SERVICE BULLETIN

No. 464A

Piper Aircraft Corporation

Subject: Inspection of Stabilator Torque Tube Bearing Block Attachment Fitting Rivets.

VIEW A-A: CORRECT RIVET ALIGNMENT

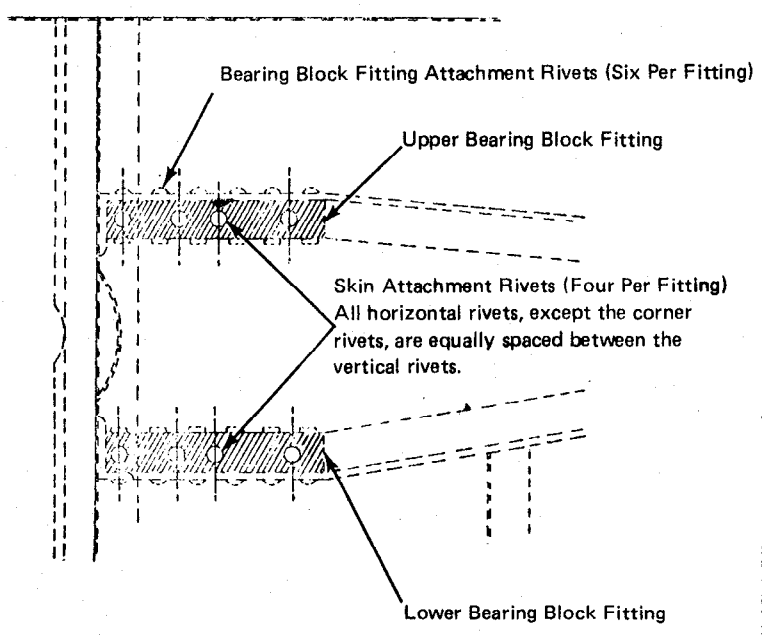
1. Remove the rear fuselage access panel located on the right side of the aircraft just forward of the stabilator.
2. Using a light and mirror (with extension), view through this access opening to determine if any of the horizontally positioned rivets through the skin align with any of the vertically positioned rivets in the bearing block (refer to attached sketch).
3. If more than two (including the corner rivet) rivet alignments/penetrations in any bearing block fitting have been ascertained, installation of Kit Number 760 835 is required in the affected bearing block fitting. Two rivet alignments/penetrations or less as described in paragraph 2, Purpose, above, requires no further action except for the appropriate log book entry.

VIEW A-A: RIVET ALIGNMENT which may have resulted in rivet penetration:

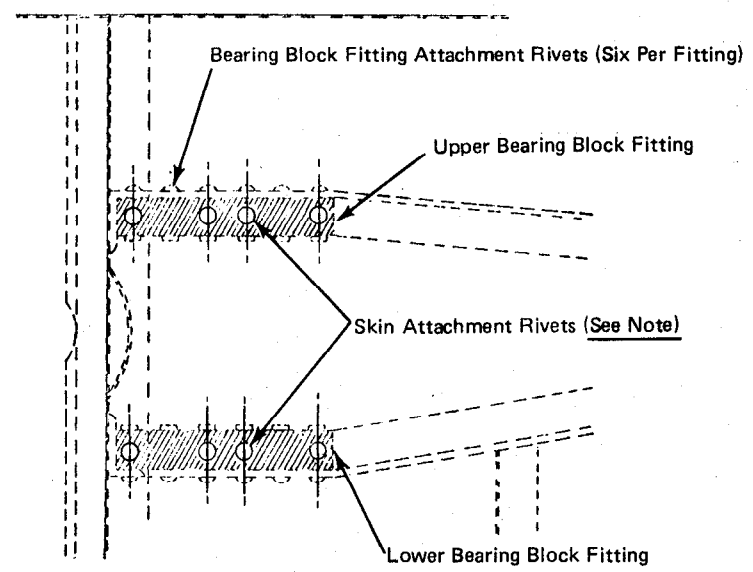
NOTE: All horizontal rivets, except the corner rivets, are incorrectly installed in this view as they are aligned with the vertical rivets. If more than two rivet alignments are evident in each fitting, it will be necessary to install Kit 760 835.

1. One (1) each PER FITTING (i.e., each kit contains sufficient material to modify one only Stabilator Torque Tube Bearing Block Fitting), Piper Kit Number 760 835, Hi Shear Rivet Replacement, if required per Instructions number 3, above.
2. Two (2) each per aircraft Cover Plate, Part Number 28216-02, if installation of Kit 760 835 is required per Instructions number 3, above.
